# Access Compliance Report

## Public Rights-of-Way

Intersection ID: 15139	Main Street: EAST_BV	Cross Street: KENILWORTH_AV	Location: E
ADA ID: 7EAFFAE162	Ramp Type: BlendTrans1	Initial Pass/Fail: Fail	Overall Compliance: No
Severity Score: 8.75			
Codes/Mitigation Info/Possible Solution		Field Measurements/Component Compliance

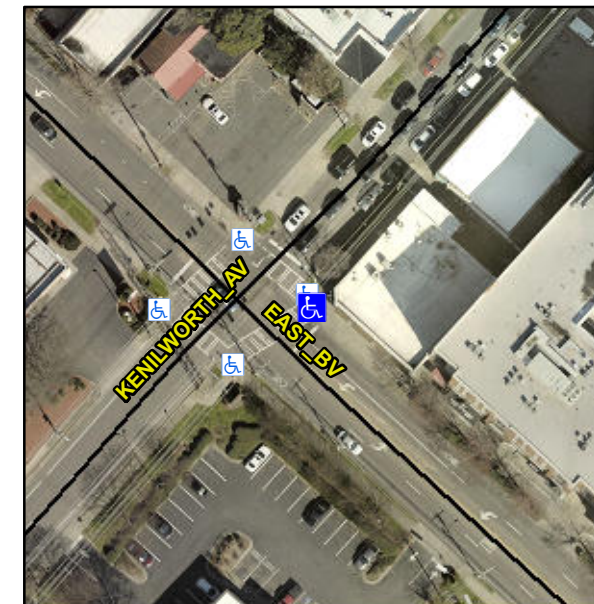
Compliance	Description	Data	Compliance	Description	Data
N/A	Ramp Length (in)	54.0	Yes	BlendTrans Slope (%)	2.2
No	Ramp Width (in)	47.0	Yes	BlendTrans XSlope (%)	0.1
N/A	Flare Type LT	N/A	N/A	Flare Type RT	N/A
N/A	Flare Slope LT (%)	N/A	N/A	Flare Slope RT (%)	N/A
N/A	Flare Traversable LT?	N/A	N/A	Flare Traversable RT?	N/A
N/A	Landing Length (in)	N/A	N/A	DWS Provided?	N/A
N/A	Landing Width (in)	N/A	N/A	DWS Contrast?	N/A
N/A	Landing Slope (%)	N/A	N/A	DWS Length (in)	N/A
N/A	Landing X Slope (%)	N/A	N/A	DWS Full Width?	N/A
N/A	Landing Curb? (Y/N)	N/A	N/A	DWS Offset (in)	N/A
N/A	Shared Landing?	N/A			
N/A	Gutter Ponding?	N/A	N/A	Gutter Slope (%)	N/A
N/A	Gutter Lip Ht (in)	N/A	N/A	Gutter X Slope (%)	N/A
N/A	Painted X Walk1?	Yes	N/A	Painted X Walk2?	N/A
	X Walk 1 Direction	To SW		X Walk 2 Direction	N/A
	X Walk 1 Width (in)	116.0		X Walk 2 Width (in)	N/A
	X Walk 1 Slope (%)	3.4		X Walk 2 Slope (%)	N/A
	X Walk 1 X Slope (%)	1.4		X Walk 2 X Slope (%)	N/A

**Remove & Replace Curb Ramp With Two New Directional Ramps or Equivalent.**

**R304.5.1**
